**Asheboro Planning Board
Asheboro City Hall (146 N. Church Street)
Monday, November 6, 2023
7:00 PM
AGENDA**

RZ-23-14: Request to rezone property located along the west side of Zoo Parkway and the south side of Newbern Avenue from R40 Low-Density Residential, R15 Low-Density Single-Family Residential, and R10 Medium-Density Residential to R7.5 (CZ) Medium-Density Residential Conditional Zoning for a Residential Planned Unit Development

CONCEPTUAL REZONING PLAN
HILLCREST FARM SUBDIVISION
RANDOLPH COUNTY, ASHEBORO, NC
AUG. 2023

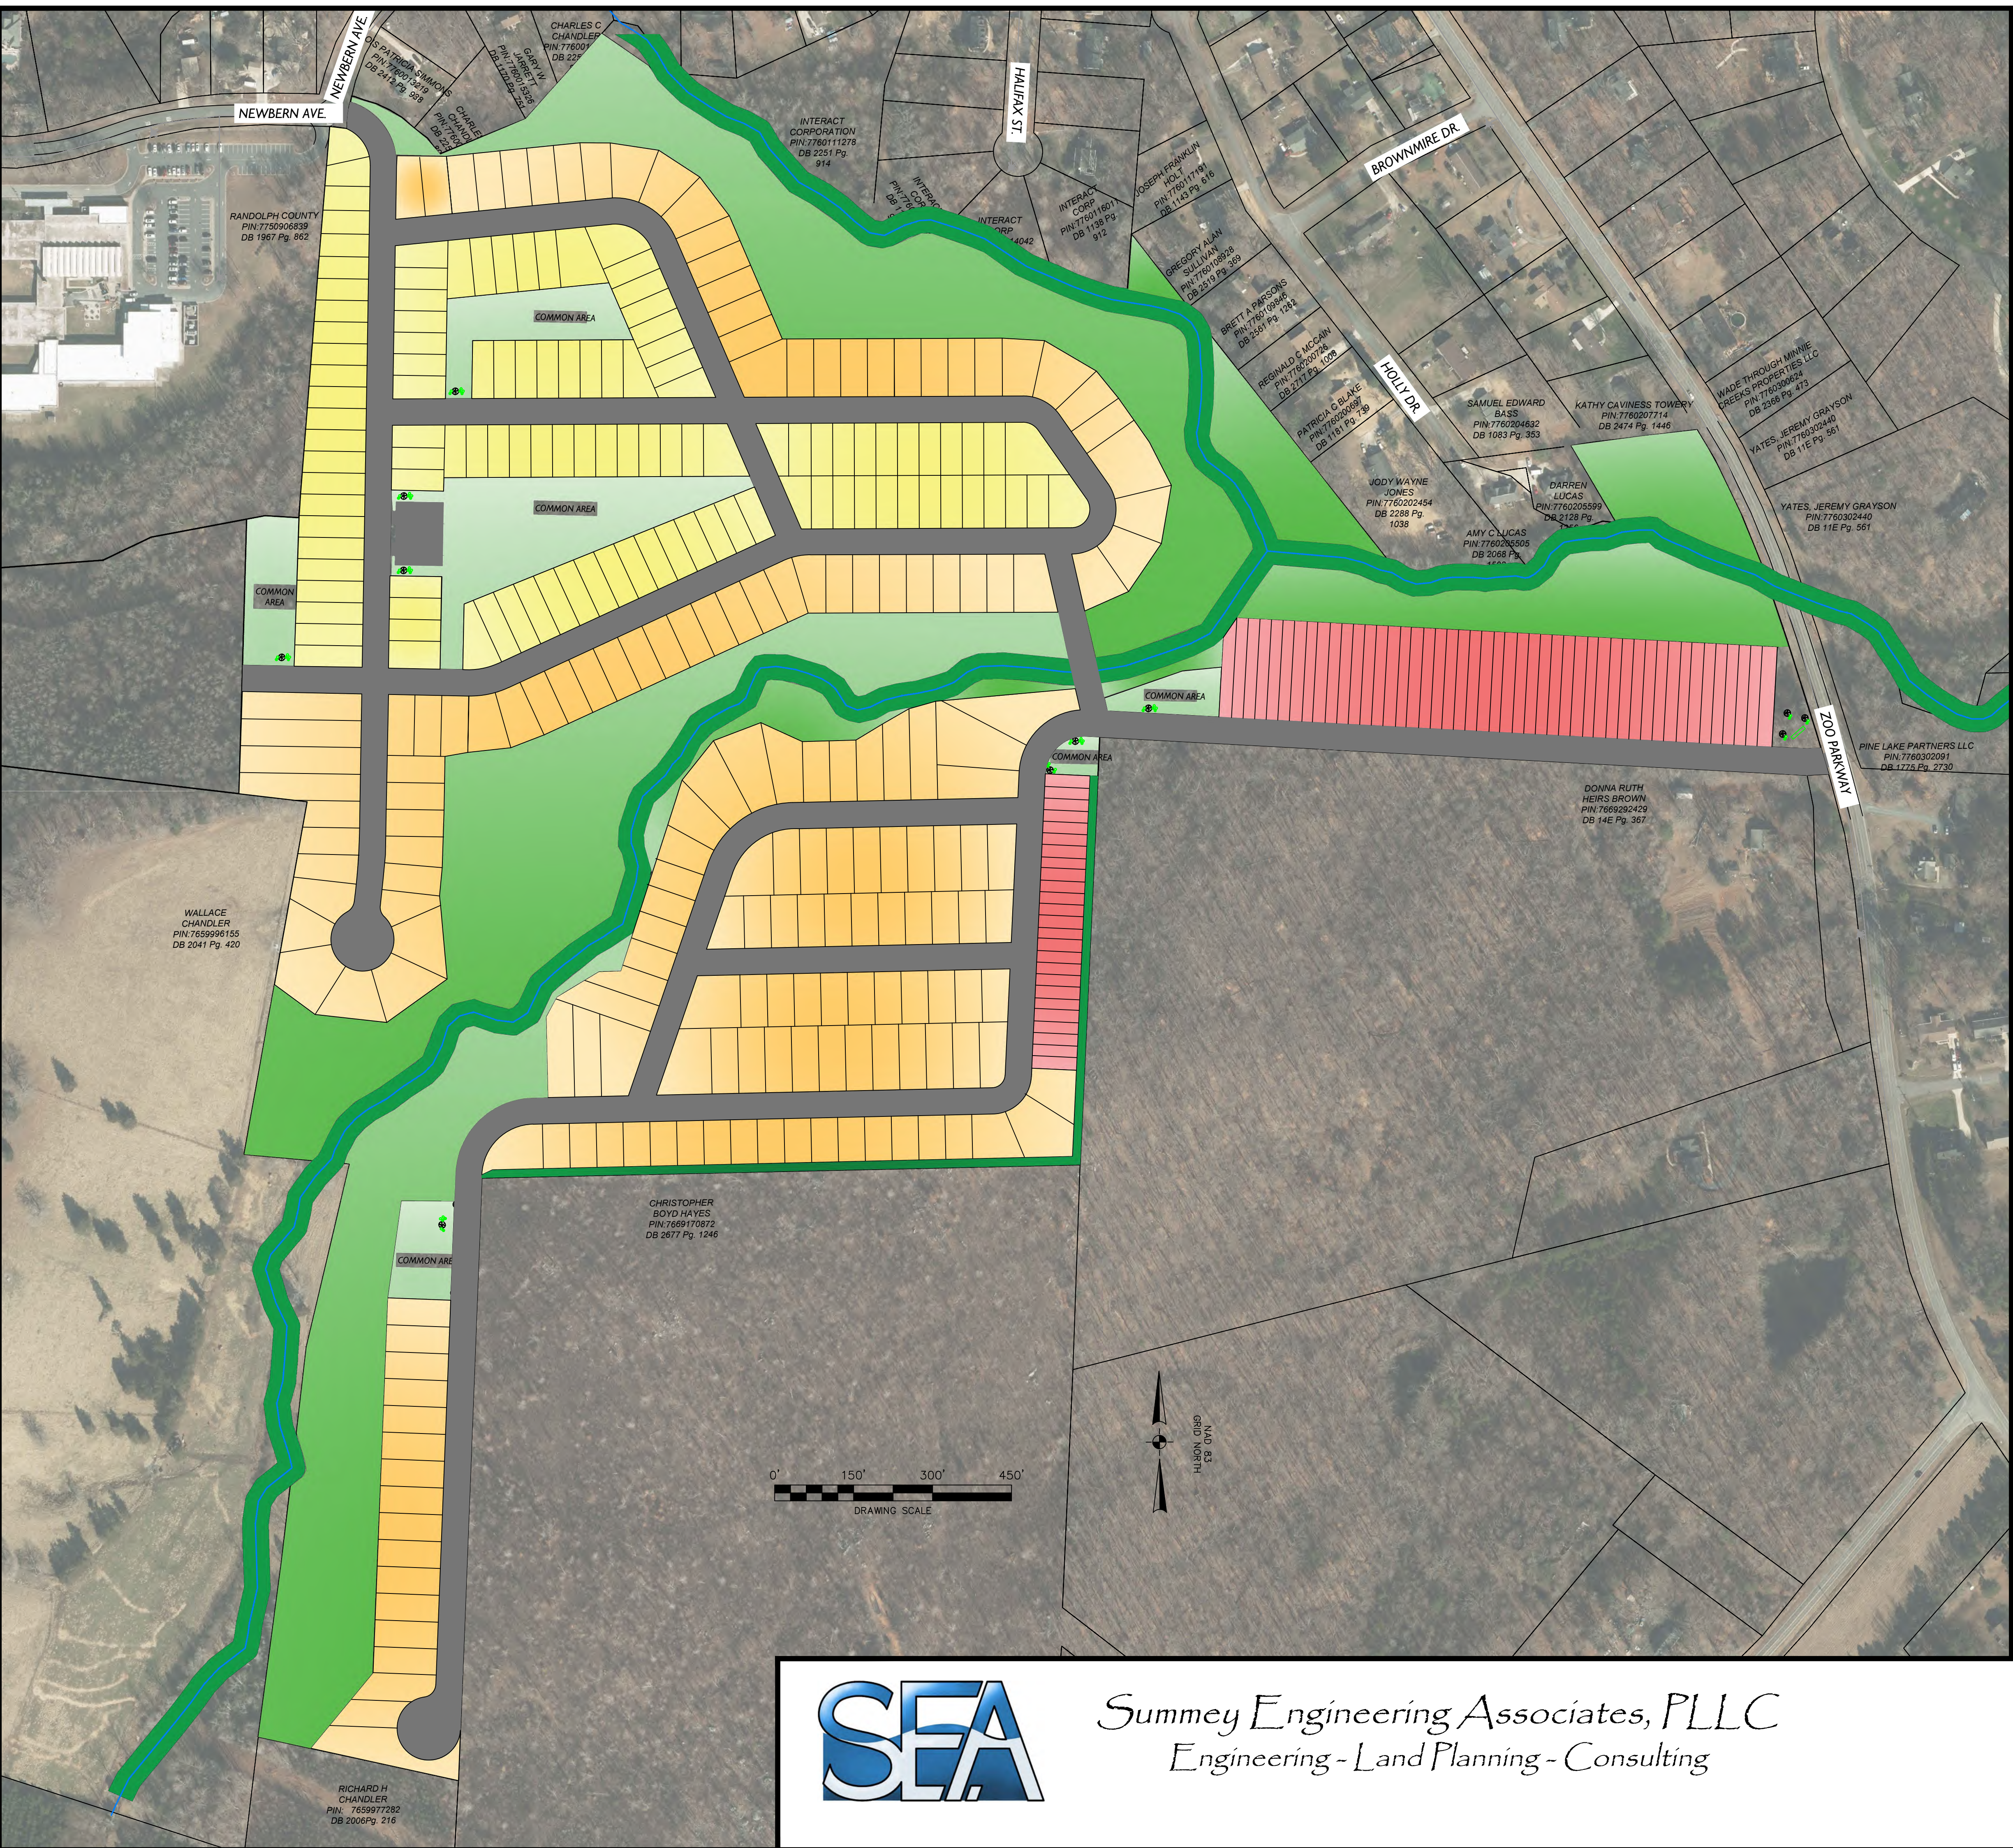
5. Plans identify certain areas for tree preservation, primarily within flood-prone areas of the property. There also is some landscape buffering shown to be provided between the development and adjacent property, with a 15 ft. natural buffer to be retained adjacent to the townhomes. Each development entrance will be landscaped with a minimum of 4 understory trees and 12 shrubs, and street trees will be installed at a rate of 1 understory tree per 25 residential units. Staff has suggested additional fencing be provided adjacent to two additional residential properties (Parcel Identification Numbers 7760013216 and 7760014240) that is not shown.

6. Sidewalks customarily are required for a Residential Planned Unit Development and typically is expected to connect all lots and amenities to existing streets. The site plan proposes a sidewalk network only on one side of the new streets which is not adequate under the code when lots are proposed to be on both sides. Staff has identified this deviation and, in response, the applicant has added a trail that would provide additional pedestrian access for many of the lots; several lots, however, remain unconnected to a pedestrian feature. Staff has provided comments to the applicant relative to pedestrian infrastructure as it currently proposed for the project.

11. The overall density of the development is approximately 4.4 dwellings per acre (when excluding public right-of-way as stipulated by the code). The plans indicate that lot sizes range from 3,000 to 4,000 SF, with minimum unit sizes of 1,150 SF of conditioned area for the attached townhomes. The plans indicate lot sizes ranging from 4,100 to 5,100 SF for the detached single-family dwellings, with minimum unit size of 1,200 SF of conditioned area for each detached dwelling.

13. Staff has continued to discuss the project with the applicant and most recently suggested that additional details or project conditions pertaining to pedestrian features, stormwater, roadway construction timing, and visitor parking may be helpful or warranted. Staff awaits submission of project revisions in response to these comments or other factors.

- (H) Prior to the recording of Memorandum of Land Use Restrictions outlined in (Z), the site plan shall be revised with the following information and resubmitted to the Planning Department for review of code compliance and inclusion in the file without further review by the Council:

- (i) Labeling of recreation area on plan sheets
 - (ii) Labeling of adjacent property zoning within 50' of subject property.
 - (iii) Labeling of all lot dimensions.

- (v) Clarification on site plan that stormwater management is the responsibility of the property owner and/or homeowners' association outside of the public right-of-way.

(P) Sidewalks meeting ADA standards or a trail shall be provided to connect units and lots, parking areas, recreation facilities, trash facilities, community mailboxes Sidewalks shall extend to intersections with existing streets and along existing public streets (except as noted below) where new curb and gutter is added; a trail network shall be built as shown on the final approved conditional zoning district site plan. Where existing and proposed streets exceed five percent (5%) grade, and sidewalks area added along those streets, sidewalks shall meet ADA standards at the intersection(s).

(AA) At least one public street stub enabling a future public road extension into the Donna Ruth Brown Heirs property, identified as Randolph County Parcel Number 7669292429, shall be built. The location and design of the street stub shall be reviewed and approved with the preliminary plat and engineering plans and in consultation with NCDOT.

(BB) At least one additional public street stub enabling a future public road extension into the Christopher Boyd Hayes property, identified by Randolph County Parcel Identification Number 7669170872, shall be built. The location and design of the street stub shall be reviewed and approved with the preliminary plat and engineering plans and in consultation with NCDOT.
